25 March 2025

Submission - Casey Fields South (Employment) and Devon Meadows PSP

Figure 5: Jacobs Proposed Transport Network

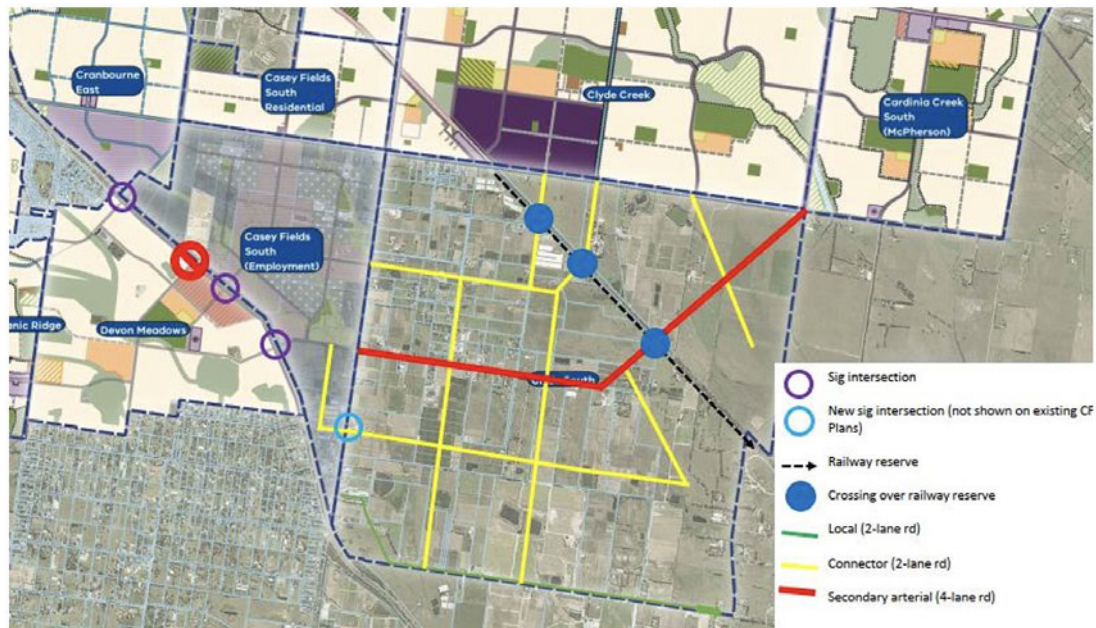
- The PSP rules out Moores Road from forming a connection from Bells Road in the north to the South Gippsland Highway as a secondary arterial road.

This is the network used in the Jacobs analysis for the PSP and shown in Figure 5.

ID_Land submits that the PSP road network prejudices the road network option shown in the Jacobs Report in Figure 5 being achieved. It does that without strategic justification and without testing the outcome of the PSP adopted road network.

To avoid delaying the adoption of the PSP, ID_Land submits that the PSP should be amended so it does not apply to land south of the Moores Road extension to South Gippsland Highway. That part of the PSP should be excised and included in the Clyde South PSP.

If the VPA adopts this approach, it will allow for the Clyde South PSP to test and resolve the road networks issues. The relevant area to be excised from the Casey Fields Employment PSP is shown in Figure 7. It is important that the option of extending Moore Road as a secondary arterial to the South Gippsland Highway is not prejudiced should that prove to be the best approach.
